Re: Florida Power & Light Company
Proposed Turkey Point Units 6 and 7
Docket Nos. 52-040 and 52-041
Response to NRC Request for Additional Information Letter No. 030
(eRAI 5818) Standard Review Plan Section 02.04.06
Probable Maximum Tsunami Flooding

Attachment 1: FPL Response to NRC RAI No. 02.04.06-4 (eRAI 5818)

Attachment 2: FPL Response to NRC RAI No. 02.04.06-6 (eRAI 5818)

NRC RAI Number: 02.04.06-6 (e-RAI 5818)

Figure 2.4.6-227 Tsunami Wave Amplitude Results for 5, 15, and 30 Min. After Slide Initiation of the Largest Landslide Within CFS Complex (Source: Reference 223)

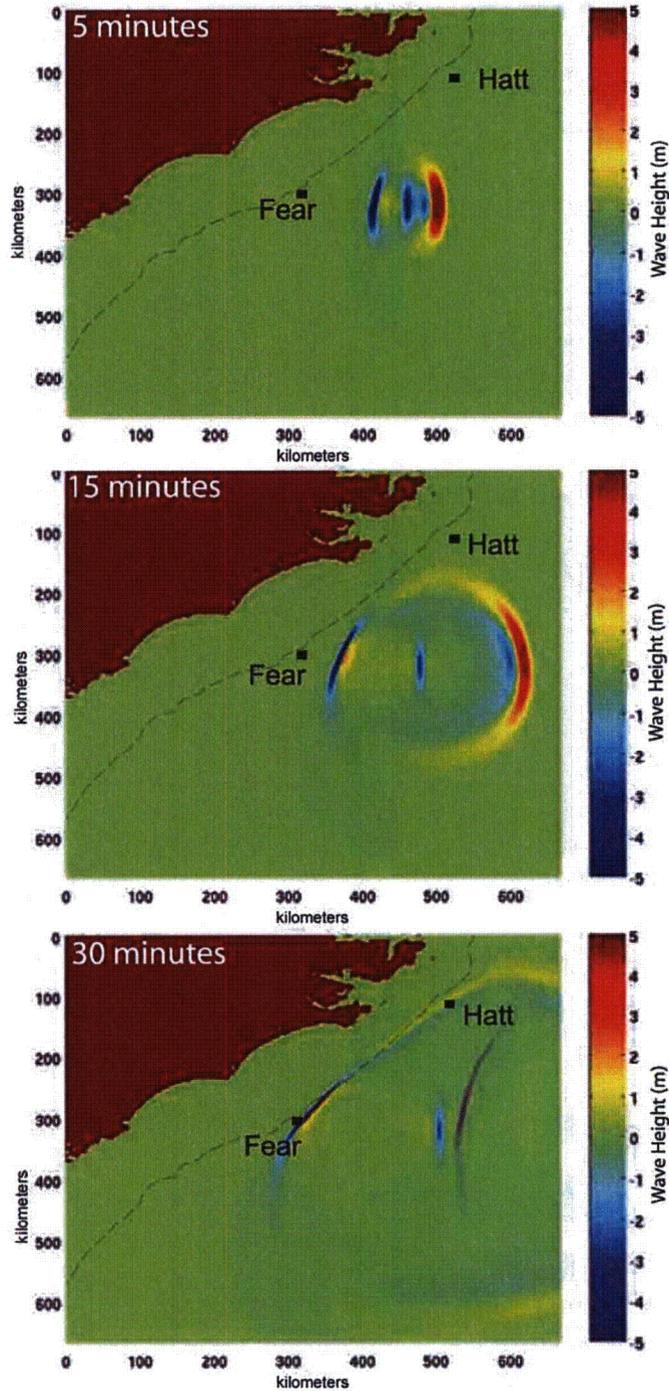
2) The assertion in FPL's response to NRC RAI 2.04.06-3 (Question 18186) that the impact of a submarine landslide to the north (offshore of the Carolinas) would be considerably reduced depends on FPL's response to NRC RAI 2.04.06-2 (Question 18185). In FPL's response to NRC RAI 2.4.6-2 (Question 18185), FPL did not specifically model tsunamis from landslides offshore of the Carolinas. Further evidence is needed to verify this assertion.

Subsection 2.4.1.1.5 does not exist in the FSAR. Justify the assertion that the Bahamas Islands shelter the site from landslide-generated tsunamis north of Puerto Rico. Justify the assertion that tsunami water levels from submarine landslides to the north (offshore of the Carolinas) would be negligible at the site.

As discussed in the FSAR Subsection 2.4.6.1.1, the largest submarine landslide area near Units 6 & 7 is identified in an area south of Cape Hatteras, off the Carolina Trough. This area includes the Cape Fear and Cape Lookout Slides. Between the two landslides, the Cape Fear Slide (CFS) complex is the larger and closer to the Units 6 & 7 site. Therefore, the CFS complex is expected to have greater impact. Literature review indicates that there was no far-field tsunami analysis performed for the landslide complex. However, Hornbach et al. (Reference 2) performed a localized tsunami simulation for the largest landside from the CFS complex and obtained an estimate of maximum tsunami wave height at 100 meters water depth. The model results include contours of tsunami amplitudes 30 minutes after initiation of the landslide (see Figure 2.4.6-227 in the attached associated COLA revision). The major tsunami waves propagate along the axis of the landslide, both toward the coast and seaward. Geometrical spreading of the tsunami wave is prominent along the direction perpendicular to the axis of slide and toward the Straits of Florida. Based on the model results, the tsunami wave amplitude 30 minutes after slide initiation and about 200 kilometers (124 miles) along the Units 6 & 7 direction is approximately 1.5 meters (4.9 feet). In contrast, the tsunami amplitude off Miami, Florida, at a water depth of 783 meters (2569 feet) for the 1755 Lisbon Earthquake tsunami (which corresponds to the probable maximum tsunami) is 2.0 meters (6.6 feet) (Reference 3). The distance between the CFS complex and off-Miami site at water depth of 783 meters (2569 feet) is more than 800 kilometers (497 miles). Therefore, the tsunami maximum water level at Units 6 & 7 site due to the CFS complex landslide would be lower than that from the 1755 Lisbon Earthquake tsunami.

Units 6 & 7 are located approximately 400 miles (640 kilometers) southwest of Blake Spur with a wide and shallow continental slope and shelf in between (Figure 2.4.6-201). Details of the Atlantic continental shelf near the site are described in Subsection 2.5.1.1.1.1. Additionally, the landslide zones are oriented in a manner that Units 6 & 7 would be away from the main axis of submarine landslide-generated tsunamis. Consequently, **the** impact of any submarine landslide-generated tsunami on the continental slope and shelf north of Blake Spur would be considerably reduced before reaching Units 6 & 7. **For example, Hornbach et al. (Reference 223) simulated a tsunami generated by the largest landslide from the CFS complex. The model results include contours of tsunami amplitudes 30 minutes after initiation of the landslide (see Figure 2.4.6-227). The major tsunami waves propagate along the axis of the landslide, both toward the**

coast and seaward. Geometrical spreading of the tsunami wave is prominent along the direction perpendicular to the axis of slide and toward the Straits of Florida. Based on the model results, the tsunami wave amplitude 30 minutes after slide initiation and about 200 kilometers (124 miles) along the Units 6 & 7 direction is approximately 1.5 meters (4.9 feet). In contrast, the tsunami amplitude off Miami, Florida, at a water depth of 783 meters (2569 feet) for the 1755 Lisbon Earthquake tsunami (which corresponds to the PMT) is 2.0 meters (6.6 feet) (Reference 209). The distance between the CFS complex and the off-Miami site at water depth of 783 meters (2569 feet) is more than 800 kilometers (497 miles). Therefore, the tsunami maximum water level at the Units 6 & 7 site due to the CFS complex landslide would be lower than that from the 1755 Lisbon Earthquake tsunami.

Figure 2.4.6-228 A Simulation Result of Maximum Open-Ocean Tsunami Amplitude Over 4.4 Hours of Propagation Time for North Puerto Rico/Lesser Antilles Subduction Zone (Source: Reference 202)

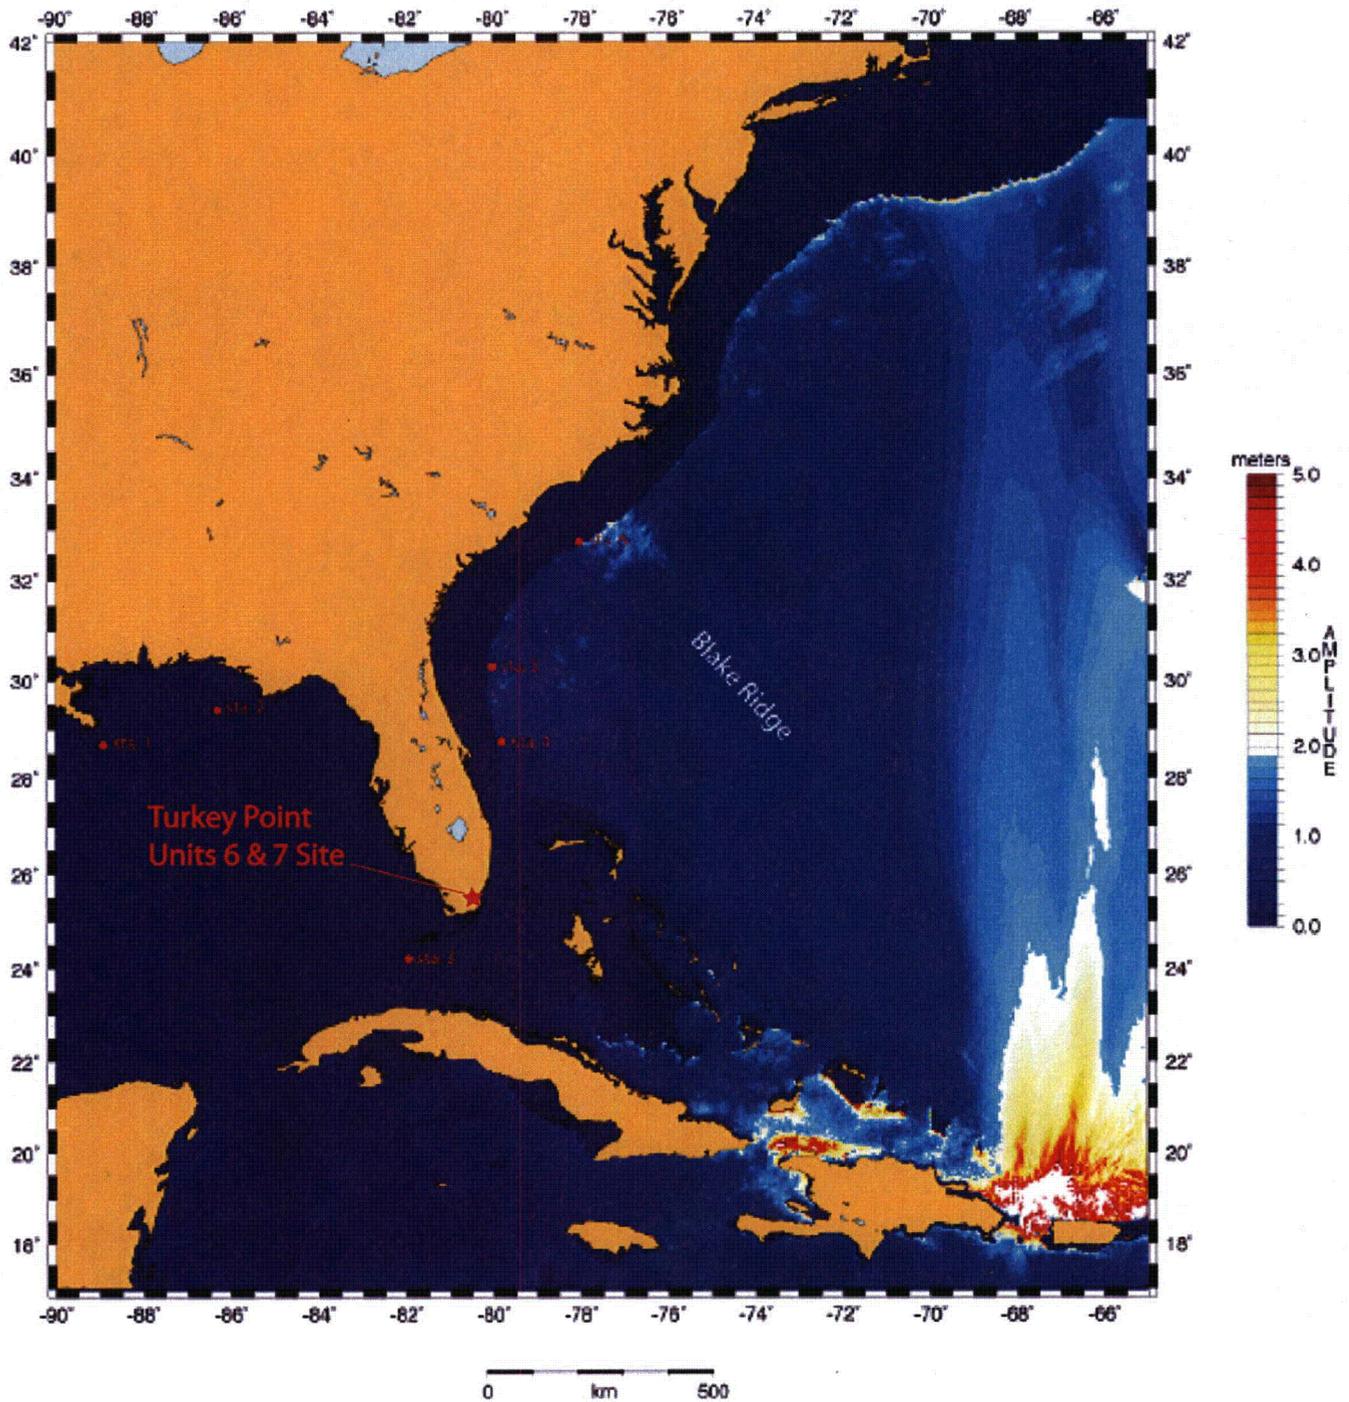
1) The assertion in FPL's response to NRC RAI 2.04.06-3 (Question 18186) that the site is sheltered by the Bahamas Islands from landslide-generated tsunamis north of Puerto Rico depends on FPL's response to NRC RAI 2.04.06-2 (Question 18185). In response to NRC RAI 2.04.06-2 (Question 18185), FPL did not specifically model tsunamis from landslides north of Puerto Rico. Further evidence is needed to verify this assertion.

Literature review indicates that no tsunami simulation was performed for landslide sources north of Puerto Rico, i.e., the Puerto Rico Trench. However, the sheltering effect of the Bahamas Islands on the Units 6 & 7 site from landslides generated north of Puerto Rico can be demonstrated based on the results of a tsunami model simulation caused by an earthquake in the Puerto Rico Trench (North Puerto Rico/Lesser Antilles subduction zone). Figure 2.4.6-228 (see the attached associated COLA revision), taken from Reference 1, shows contours of tsunami amplitudes and the associated regional tsunami propagation pattern due to an earthquake at the Puerto Rico Trench. As indicated in the figure, the southeast Florida coast is sheltered by the Bahamas from tsunami waves generated in the area north of Puerto Rico. Although the mechanism of tsunami generation by earthquakes and landslides is different, the regional tsunami propagation pattern between the two is expected to be similar for the Puerto Rico Trench area. As Figure 2.4.6-228 indicates, the apparent earthquake tsunami beaming is along an

azimuth perpendicular to the strike, i.e., in the north direction. For a landslide tsunami that may originate in the Puerto Rico Trench, the direction of the seaward tsunami propagation would also be in the north direction, and the tsunami amplitude would be relatively lower at far-field. This is because landslide tsunamis are greatly attenuated at far-field due to non-linear and dispersive effects compared to earthquake tsunamis (Reference 1). Therefore, a landslide in the carbonate platform north of Puerto Rico is not considered a PMT source for the Units 6 & 7 site.

The relatively small tsunami amplitude near Units 6 & 7 is primarily a result of the presence of the Bahama platform to the east, as shown in Figure 2.4.6-208 **and Figure 2.4.6-228.**
